Naz Knitwear Ltd (10653)

Anwar Plaza, Ganakbari, Savar

07.APRIL.2014

**Uncertainty Regarding Flat Slab/Beam Slab Locations
and Corresponding Lateral Stability**

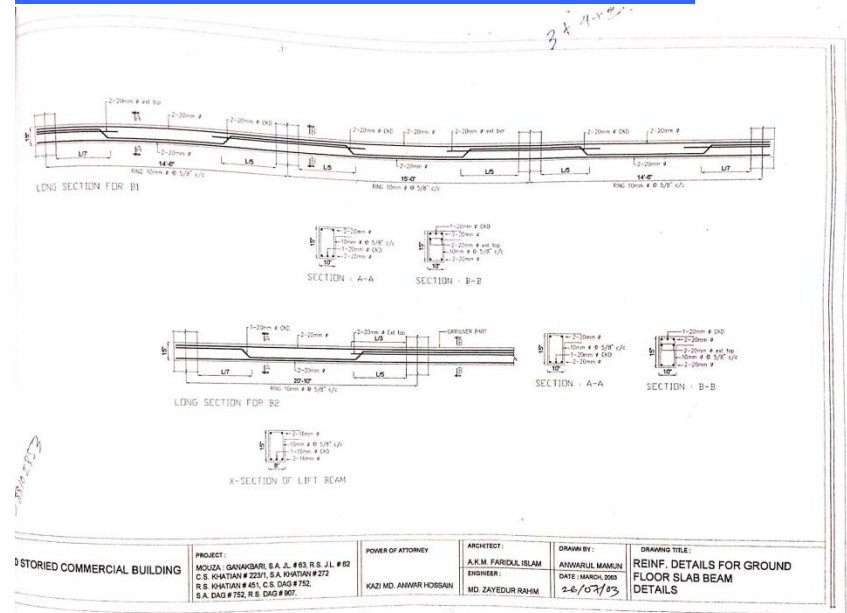
Structural drawings were unclear as to which levels of the building were intended to be flat slabs and which were intended to be beam slab arrangements as no beam layout plans were provided nor were beams shown on slab reinforcing plans. Only the 3rd floor slab was constructed as a beam slab arrangement while all others were flat slabs. Additionally this leads to concern regarding the lateral restraint system. At all floors other than the 3rd floor slab (moment frames), there was no apparent lateral restraint system in place.

ITEM 1: (Priority 2) Structural drawings were unclear as to which floors have beams and which are intended to be flat slabs. Beams were observed only at the third floor slab while structural beam details indicate beams are at the ground floor level. Furthermore, no beam layout plans are provided and no beams are shown on floor slab reinforcing plans. The stories with flat slab arrangements lack an apparent lateral stability system.

- The original design engineer is to verify the construction and provide a letter confirming that slab construction has been built as intended.
- Commence a Detailed Engineering Assessment upon structure's lateral stability system.

- Implement any recommendations and remedial works required by the design engineer and/or the detailed engineering assessment.
